From: Richard L. Mator <richard.mator@jci.com>
Sent: Thursday, July 12, 2018 4:29 PM
To: Chronert, Roxanne N - DNR; Neste, David E - DNR
Cc: Merry, JaNelle P - DNR; Christopher D Behrend; Bedard, Michael
Subject: Tyco Marinette Site Investigation - MW-100 Well Cluster Location

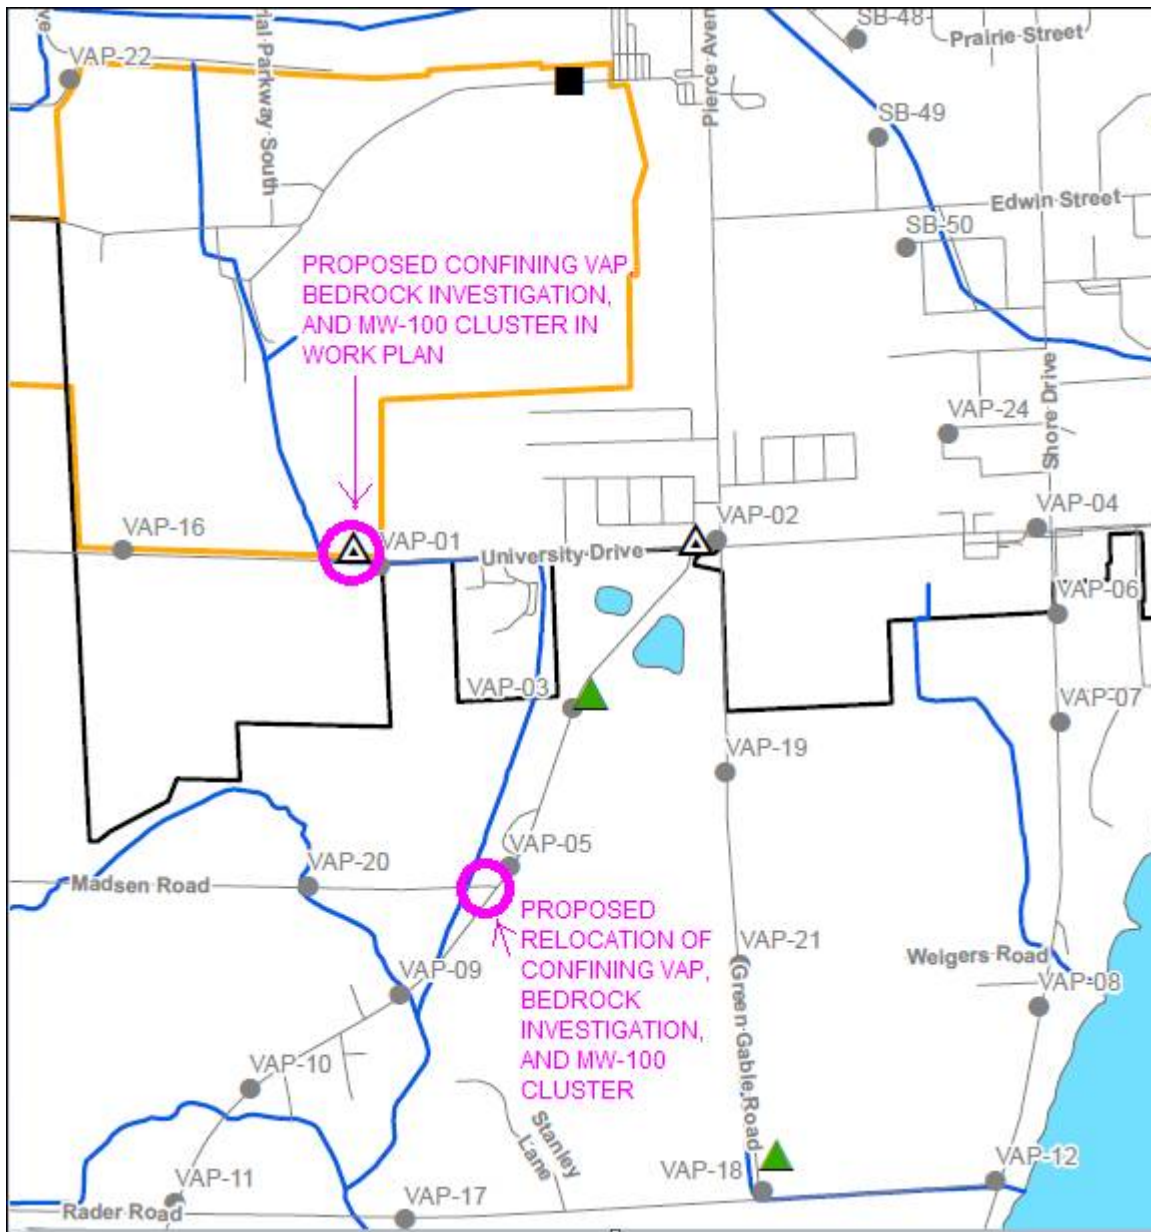
As we discussed, Tyco plans to move the location of the proposed MW-100 well cluster (three permanent groundwater monitoring wells) due to access constraints associated with the originally proposed location, and also to provide more useful information during this field mobilization based on subsurface observations made so far during the present phase of the investigation. Some considerations associated with this location change are as follows:

- The first image below illustrates the originally-proposed investigation/MW-100 well cluster location presented in the Site Investigation Work Plan, as well as the newly-proposed location on the south side of Madsen Rd, near the corner of Madsen Rd and County Rd B. The location change is planned for the following reasons:

- The originally-proposed location was partly flooded at the start of the investigation activities, and would be inaccessible for a drill rig without significant forest clearing and road building. Also, because the area is prone to flooding, the wells would be at risk of damage, or inaccessible during periods of high water.

- Several nearby alternate locations were evaluated in the right-of-way (ROW) of University Drive or County Road B; however, the presence of utilities and road-side ditches and swales eliminated all suitable locations. On County Road B, we also want to maintain distance between the MW-100 cluster and the MW-101 cluster that recently was installed near the corner of University Drive and County Road B.

- The proposed new Madsen Avenue location is approximately 2,700 feet southeast of the original MW-100 location, but would be useful to determine whether the characteristics of the dolomite bedrock remain consistent trending south into Peshtigo, where a number of private groundwater wells within the study area are located.

- The second image below presents the approximate work area for the investigation and installation of the MW-100 well cluster. Well depths will be associated with the water table, base of sand unit, and bedrock. All work will be conducted in the Town of Peshtigo ROW, and we will make sure we have well installation approval from the Town of Peshtigo for before installing wells at this location.
